# GRYPHON

## REQUEST FOR INSPECTION

Climbing Technology has issued a voluntarily request for inspection of the Gryphon (Ref. No. 7H174) and Gryphon Ascender (Ref. No. 7H178) full body harnesses by the user.

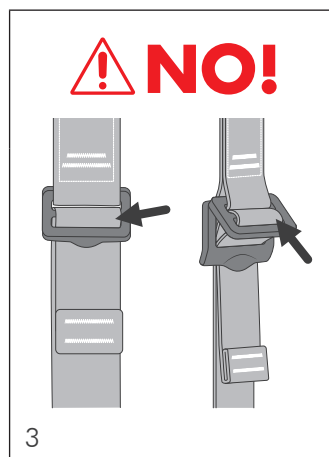
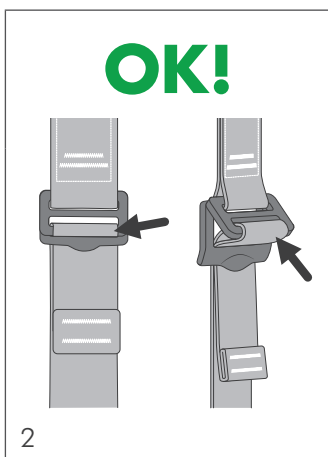
It has come to our attention that there might be the possibility of a miss-threaded shoulder strap in the adjustment buckle **B** (Figure 1). This error can lead to difficulties in the adjustment of the harness.

Because of this, when donning the harness, the shoulder strap can easily loosen making it impossible to correctly adjust the harness. To date, only one harness with this issue has been identified and no accidents have been reported.

We ask you to carry out the inspection procedure indicated below. If the product in your possession is affected by this problem, please contact us to arrange shipment at our expense:

### CONTROL PROCEDURE

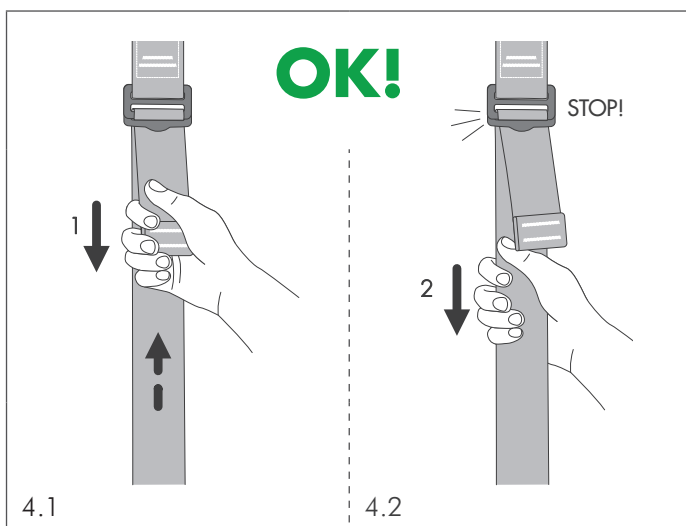
Visually control every buckle present on the harness, except the quick release buckles: verify the correct threading of the webbing (Fig. 2).

Carry out a functional check of the adjustment system for each buckle.

- 1) Pull the outer part of the strap (Fig. 4.1-5.1);
- 2) After that, pull the inner part of the strap (Fig. 4.2-5.2):
  - if the strap remains stable in its position, the adjustment system is working correctly (Fig. 4.1-4.2);
  - if the strap is free to move inside the adjustment system, the buckle is affected by the error (Fig. 5.1-5.2). Stop using the harness and follow the instructions indicated on the previous page.
